Revisions and Modifications for version 5:

D1200719-v5
High Stability, Low Noise
Laser Current Driver

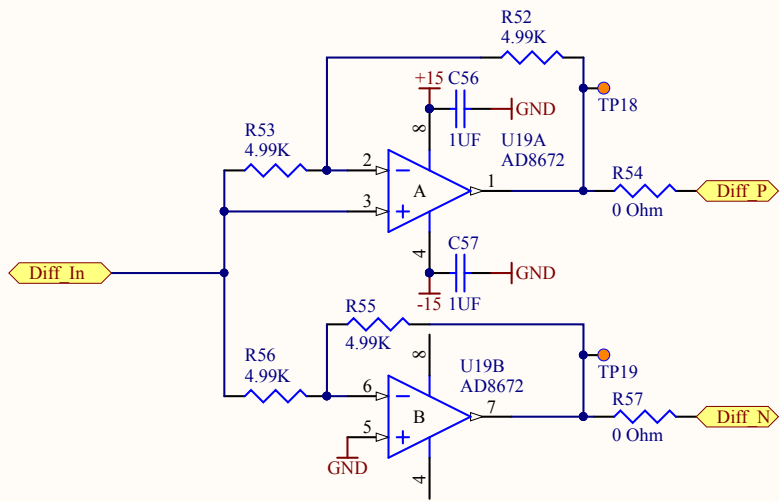
1. Used shorter heat sinks for regulators so it will fit in a 1U chassis.
2. Finned voltage reference is a 10V part. The bill of materials had this at 5V.

3. R42 changed from 750 to 2.21k to provide about 15VDC regulated power for the laser diode.
4. Added a 499k resistor to pick up the Vref connection, thus improving the accuracy of the current monitor.

5. Put a FET back onto the base drive of the main current modulator to eliminate base current error.
6. Changed R44 to 10k to make current readout more reasonable.

7. Diode protection of U9 by back-to-back diodes across positive and negative inputs.
8. Change C14 from 68pF to 27pF for less compensation of the AD829.

9. Add provision to drive the chassis rear panel LEDs for +/- 15VDC.
10. Change C39 to 100pF.
11. Change C35 to 10nF to 1uF, should update footprint to leaded plastic capacitor.

12. Q1 E-B Backwards on PCB.
13. Change R31 from 100 to 50 ohms to increase the current range.
14. Added protection diode to Q1 base (D12).

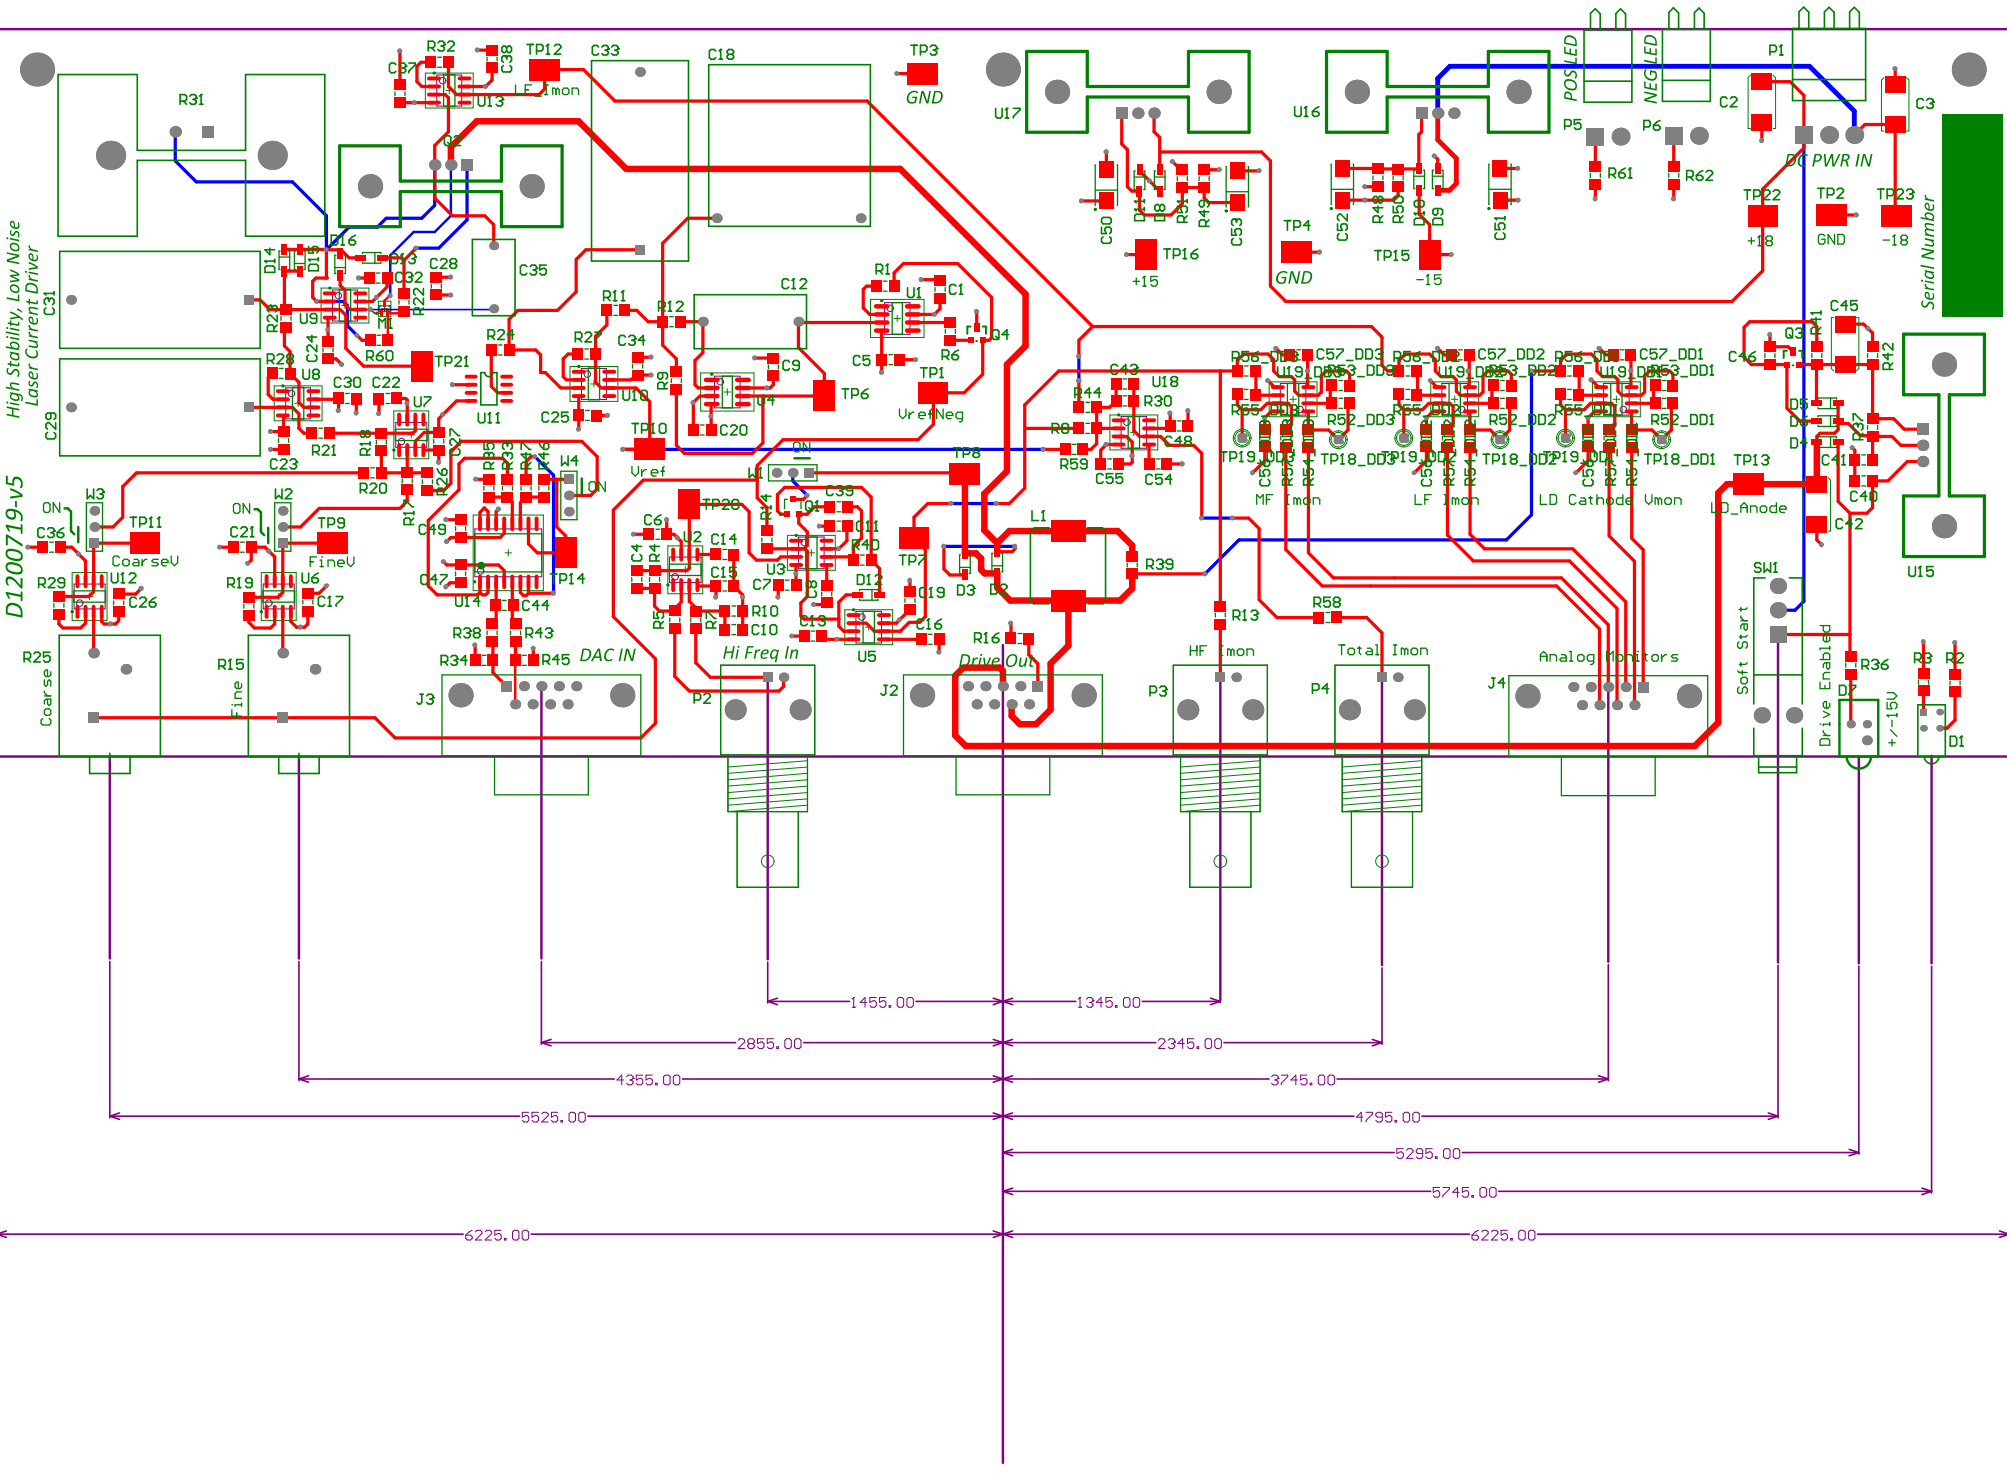
1. Due to several MHz oscillation in the high frequency current source, R40 changes from 1k to zero ohms.
